Location Address: 1105-1107 S. 19 Ave
Lot(s): 28 Block(s): 10 Subdivision: South Side Add no. 2
Folio Number(s): 5142 22 10 2000

Explanation of Request: 18-unit Multi-Family Development

SUBJECT: Preliminary Site Plan review for an 18-unit residential development. (1105-1107 S 19 Ave).

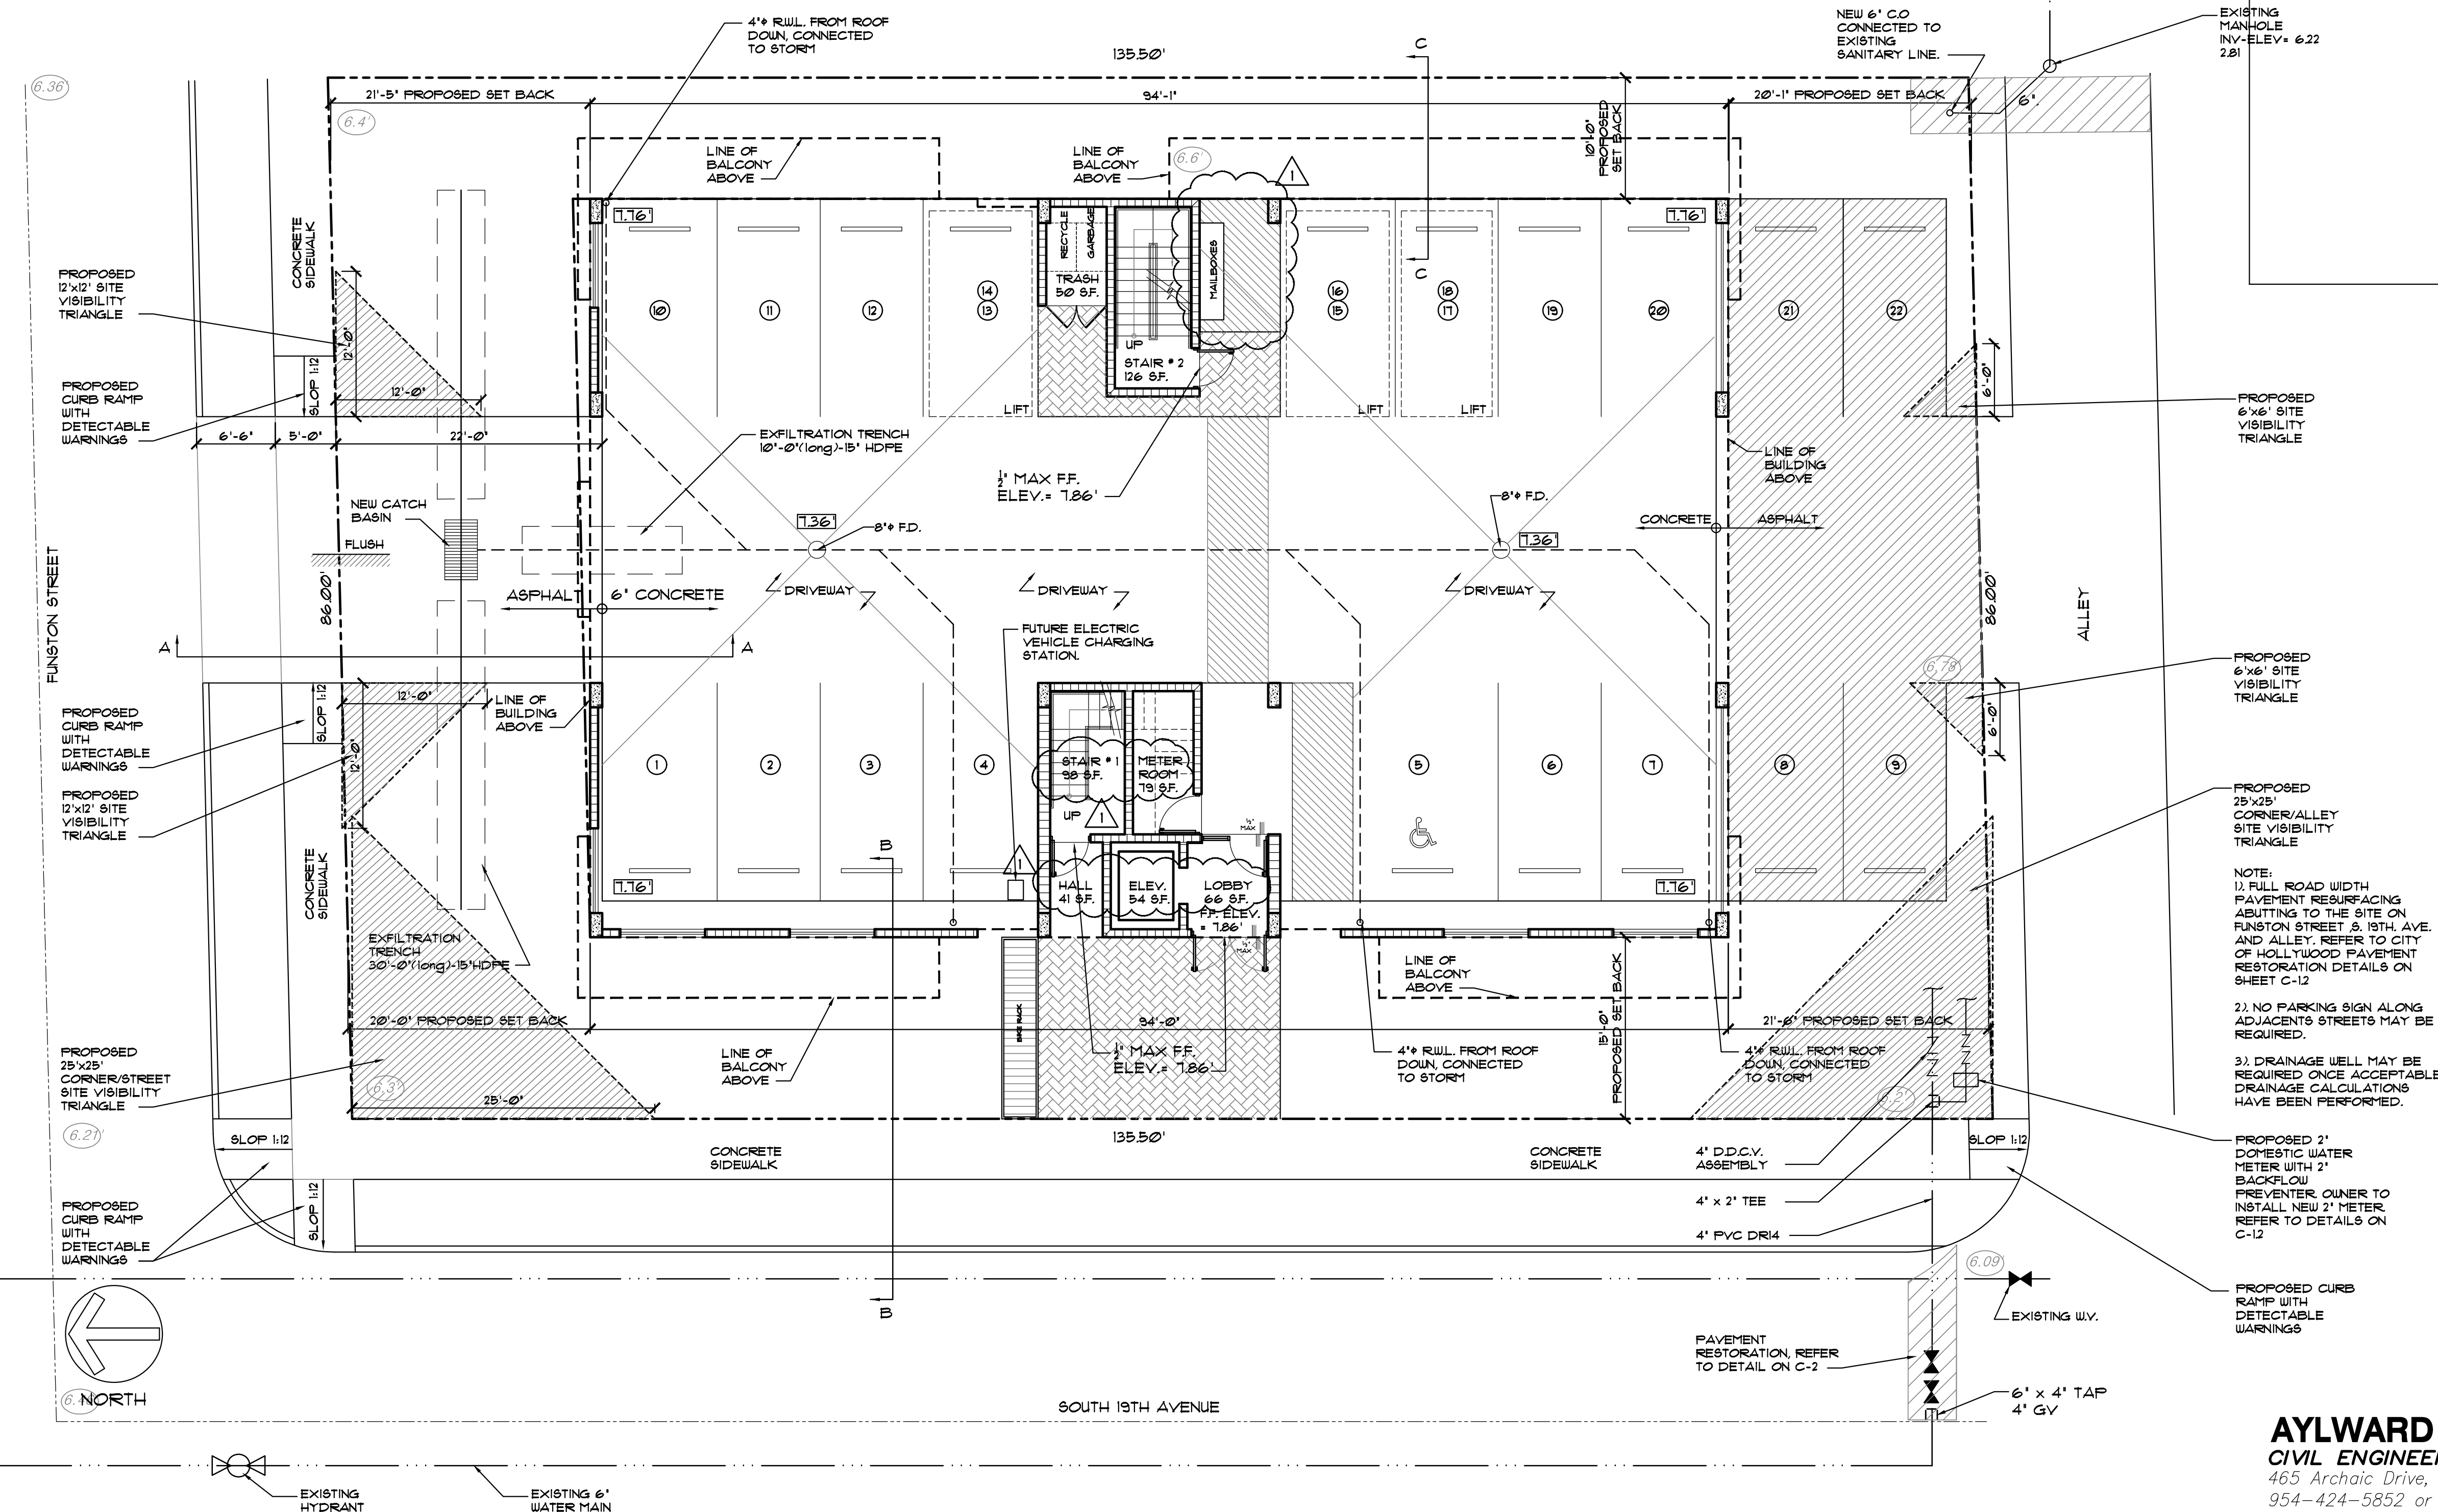
2. Provide full set of civil plans for the proposed work. Provide and indicate items such as but not limited to drainage improvements, curbing, all vehicle turning radii, sight triangles, pavement marking and signage plans and details as well as change in elevations to show that handicap accessibility has been met. For water and sanitary sewer connection, show any pavement restoration and details required for connections within City rights-of-way.

5. Provide civil engineering streetscape plans and plan details, showing proposed new sidewalks and curbs along Funston Street and S. 19 Ave. in front of the property.

8. Provide curb ramp with detectable warnings at all accessible crossing. Provide detail for detectable warnings.

3. Show perimeter cross sections across all property limits including transition areas meeting adjacent property grades with 6" swales ensuring all stormwater is retained onsite.

5. Show existing site grades from survey on Sheet C-1.1.

2. No civil drawings were turned in for the underground fire main. Provide such including location of fire department connection, DDCV, and size of fire line from water supply. Check with our water department engineer for city requirements in addition to fire. Ensure plans that there is a fire hydrant within 100 feet of fire department connections.

3. Provide a note on civil drawing all underground fire main work must be completed by fire protection contractor holding a Class I, II, or V license per FS 633.102.

Response: refer to C-1.1

Response: Refer to C-1.1

Response: Refer to C-1.1

Response: Refer to C-1.1.

Response: Refer to C-1.1

Response: Provided sheet C-1.1

Response: Note Provided on C-1.1

5 PROPOSED SITE PLAN

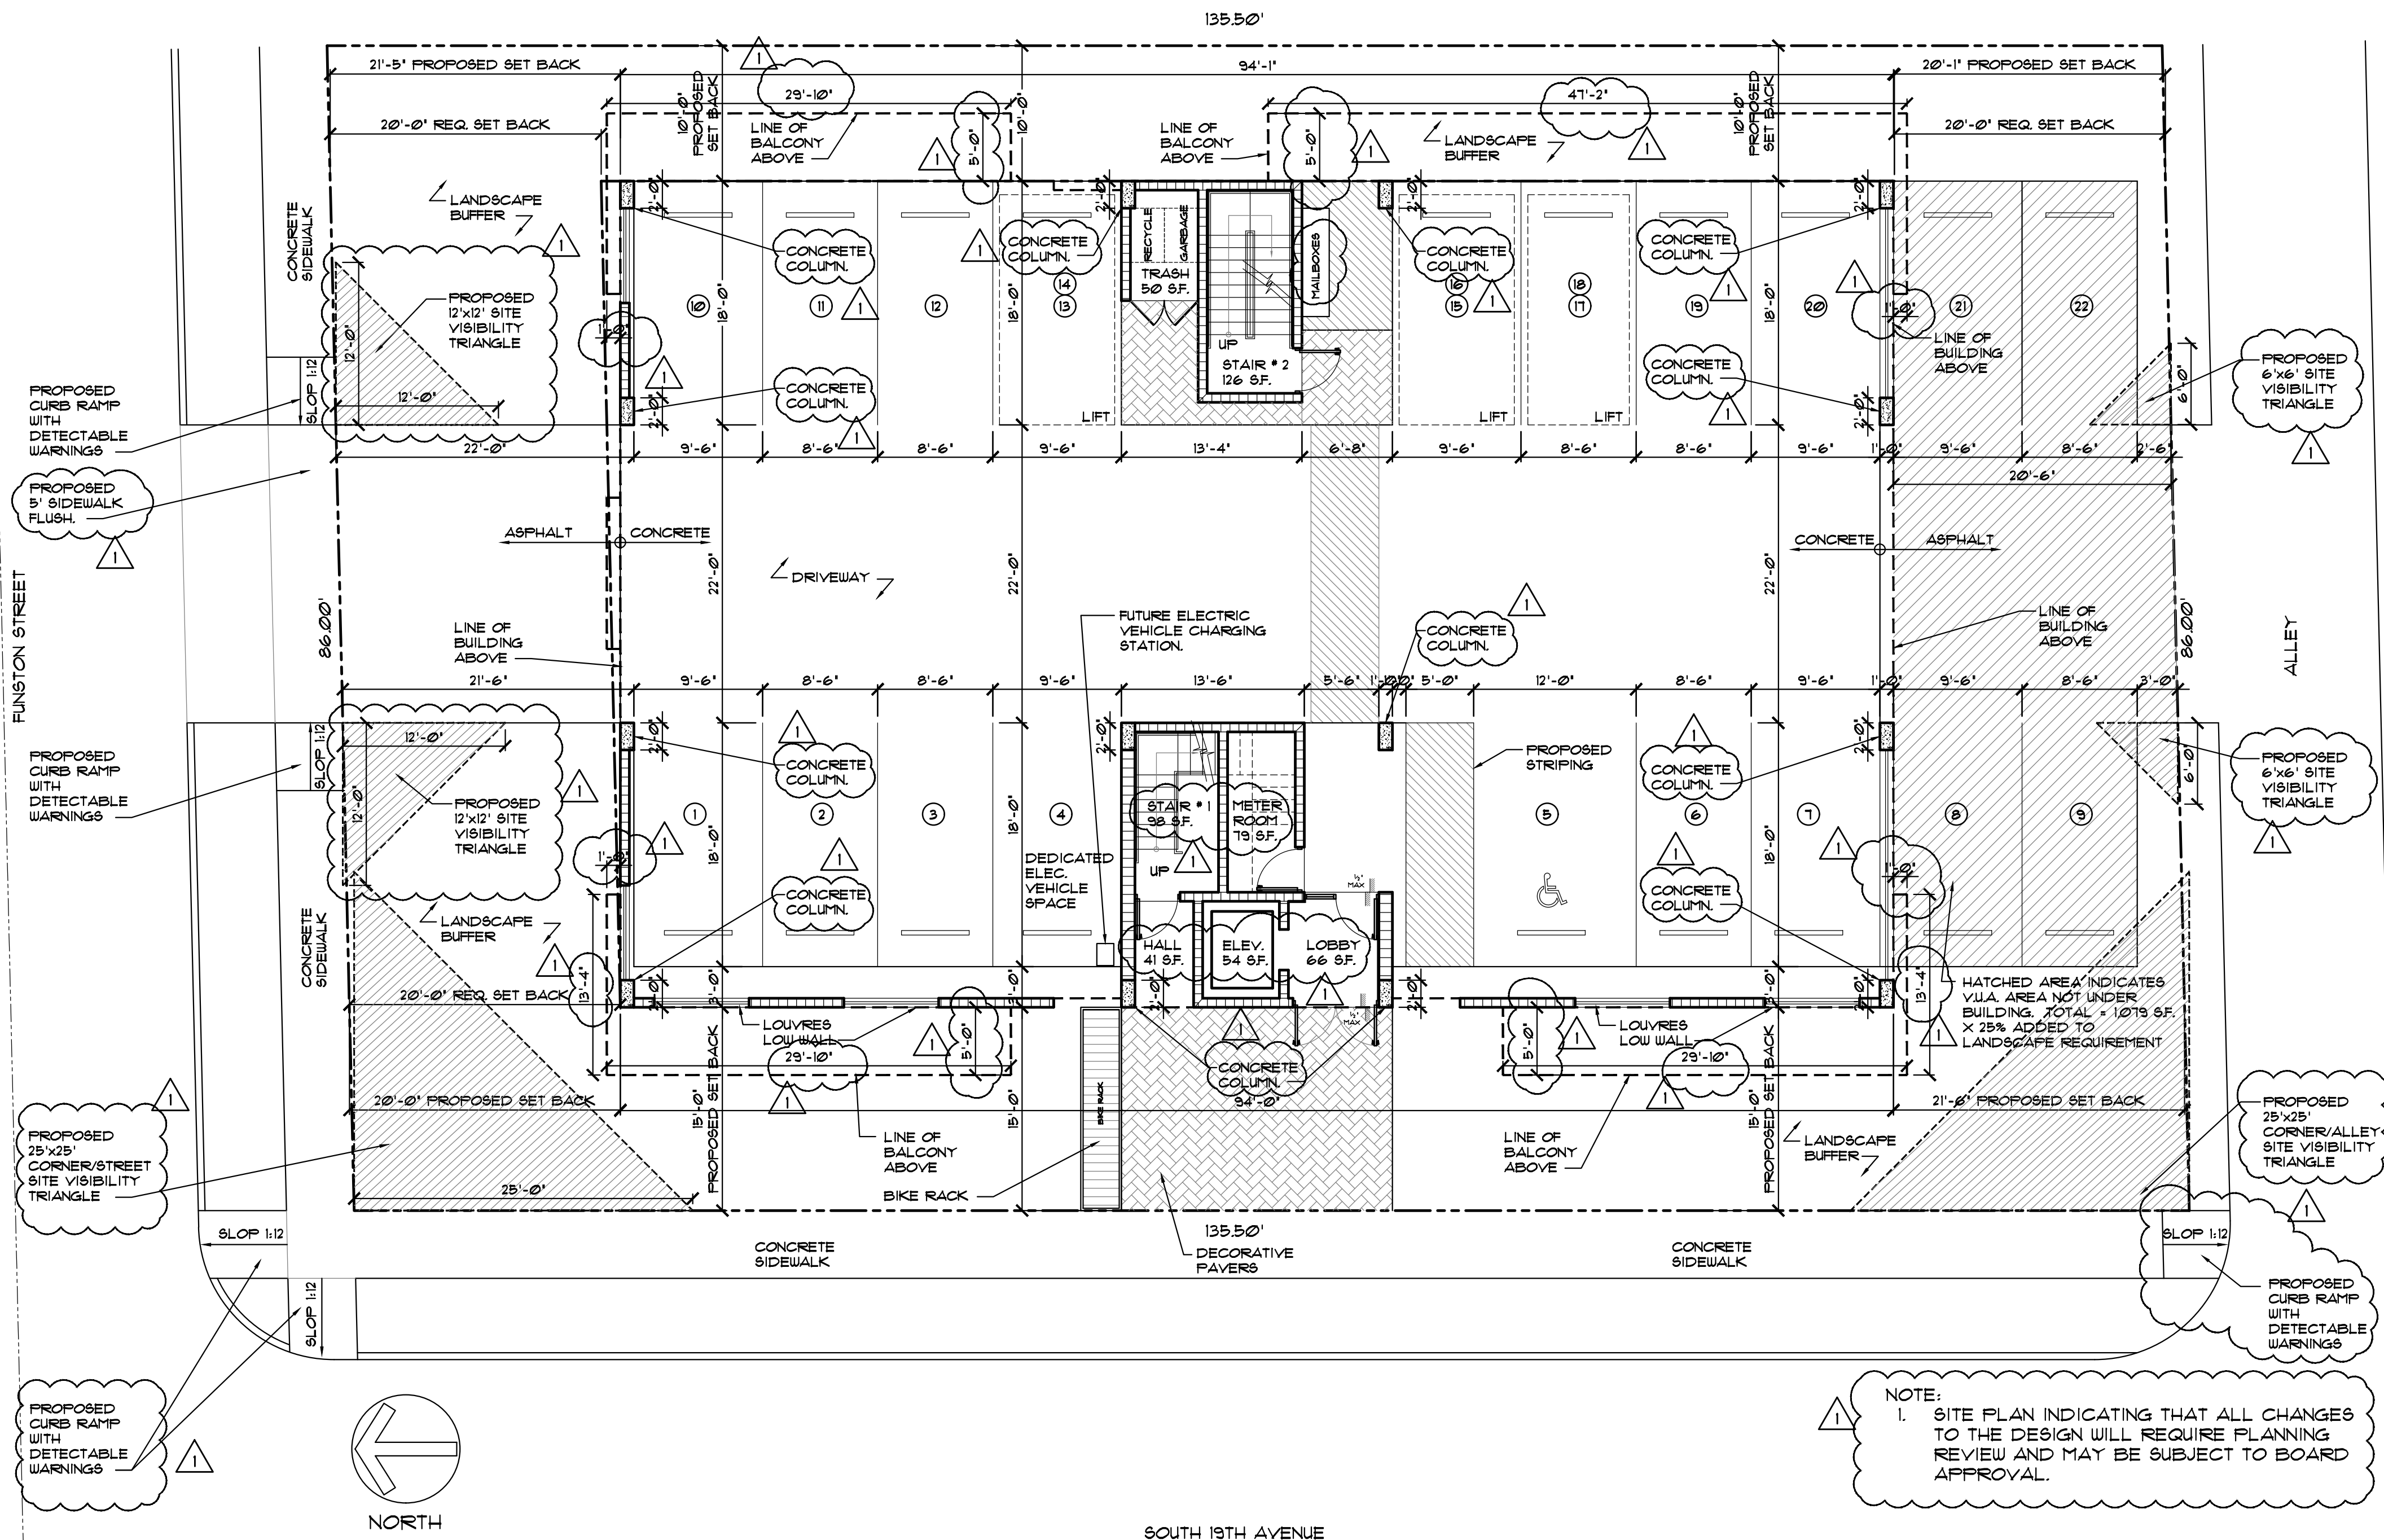
- a. Include note on Site Plan indicating that all changes to the design will require planning review and may be subject to Board approval.

- b. Provide dimensions or balconies and overhangs above.

- d. Provide method of mail delivery.

1. Minimum required rear setback for the at-grade parking is five feet. Revise accordingly.

4. At-grade parking garages shall be screened on all sides with both architectural treatment and landscape buffer. Include proposed solutions on site plan and elevations.

5. Parking stall 8 does not meet the minimum width requirements. Revise accordingly.

6. Provide additional information regarding mechanical parking lifts.
 - a. Lifts shall require assigned parking.

1. Include note on Site Plan stating the maximum foot-candle level at all property lines (maximum 0.5 allowed).

1. As per the green building ordinance in Chapter 151, the project must include at least ten green building practices since this project has less than 20,000 square feet of total floor area. Include this list on the site plan. (See 151.150-151.160)

1. For the parking garage, indicate location of building structural columns. Columns shall not be within 3 feet of the entrance of a parking stall. Add dimensions to your plan.

3. Garage required 1 Van-Accessible ADA Parking Spaces with access aisle located in the right side of the parking. Identify location in the plans.

11. Show a view triangle of 12'x12' in the exit/entrance of the parking lot to Funston Street, 6'x6' in the exit/entrance of the parking lot to the Alley way, a corner view triangle of 25'x25' in the interception of Funston St. and S 19 Ave, and a 6'x6' view triangle in the interception of the Alley way with S. 19 Ave

Response: Refer to SP-1.1 note was added

Response: Refer to SP-1.1 dimensions were added

Response: Refer to SP-1.1 and A-1.1 showing mailbox location

Response: Refer to SP-1.1 showing updated table

Response: Refer to SP-1.1 and Elevations showing screening for parking. Parking outside of building will be screened with min 42" high landscape.

Response: Refer to SP-1.1

Response: Refer to SP-1.1 showing location of lifts to be used for 2-bedroom units only.

Response: Added note on SP-1.1

Response: Refer to SP-1.1 showing 10 green building practices we are using.

Response: refer to SP-1.1

Response: refer to SP-1.1 provided

Response: refer to SP-1.1 and C-1.1
